CAMPAIGN BULLETIN

Subject: **Safety Recall 08C4**
Sterling 360 Turbocharger Bracket

Safety Recall Bulletin 08C4

3.2 Remove the turbocharger bracket and spacer

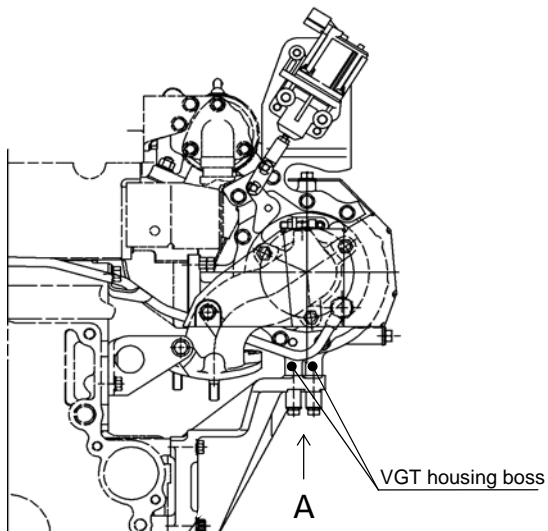
Note Don't break the 4 bolts ( ) which are tighten to crankcase because the bolt is reusable.

ENG Rear Side View

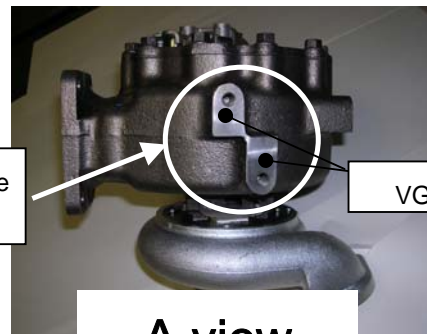
Conduct a penetrant inspection to confirm existence of crack occurrence around VGT housing boss. If a crack is found, replace VGT with a new one. → Jump to chapter "4".

Confirm existence of crack occurrence around VGT housing (See white

3.3 Install the countermeasure one.

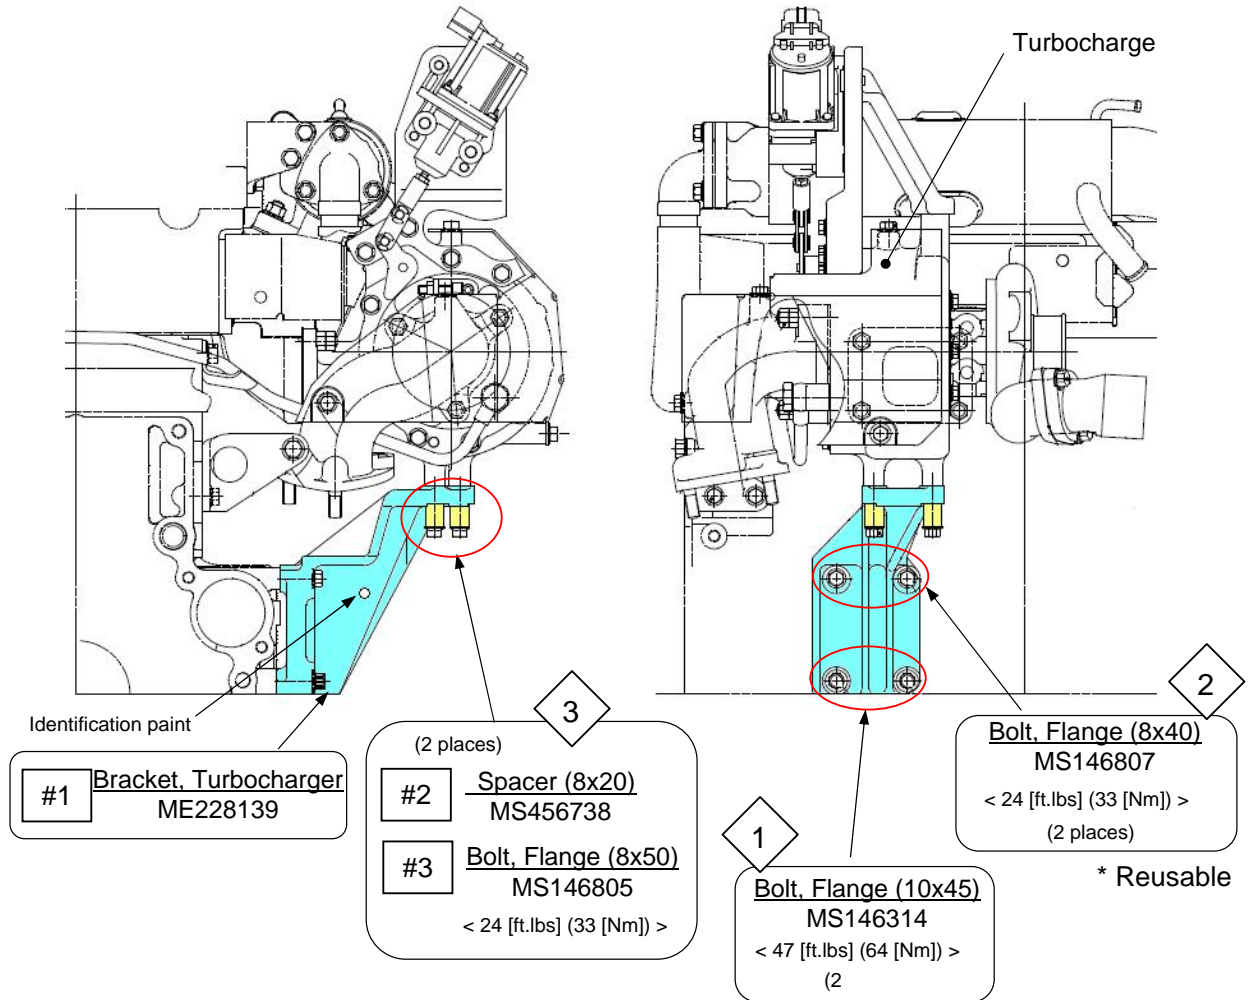
3.3.1 Tighten the all 6 bolts temporarily and check that there is no space on mounting surface.

3.3.2 Tighten the bolts of crankcase side first (Lower side **1** → Upper side **2**), and then tighten the bolts of the turbocharger side **3** with specified torque.

4.2.11 Remove the T/C and replace with countermeasure one

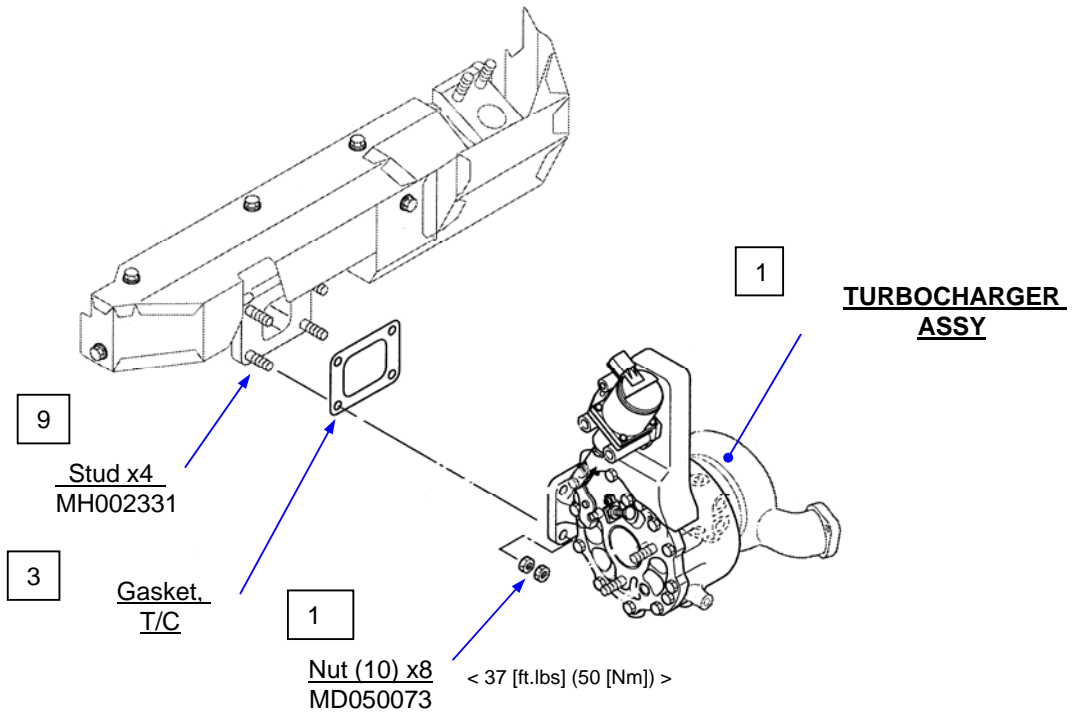
Note; In case that it's difficult to remove the T/C, refer to next page

Right side view

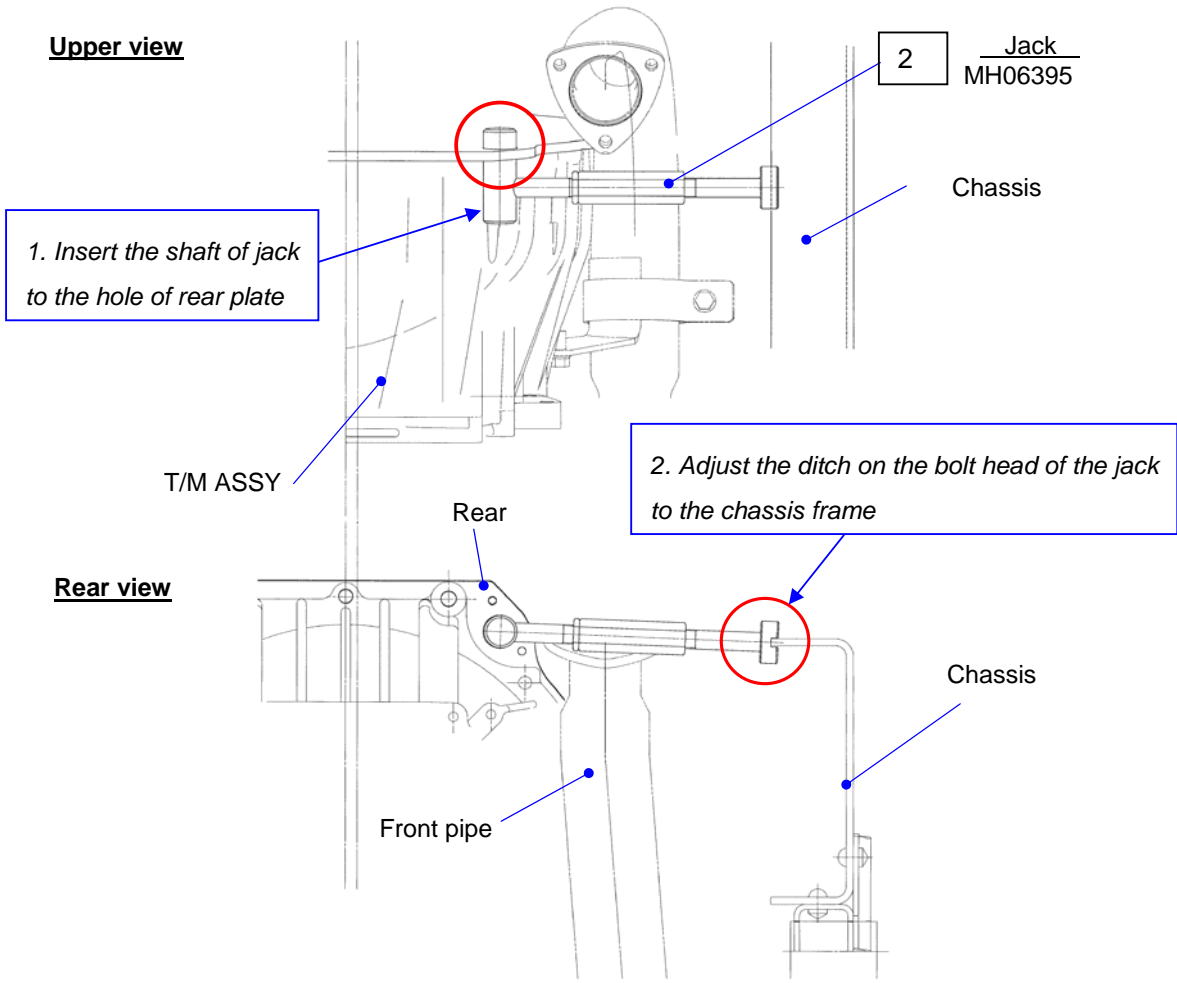
If it is difficult to remove the T/C, use the Jack<MH063952> in order to expand the space between engine and chassis frame

3. Rotate the turnbuckle of jack to the direction of the arrow with a spanner
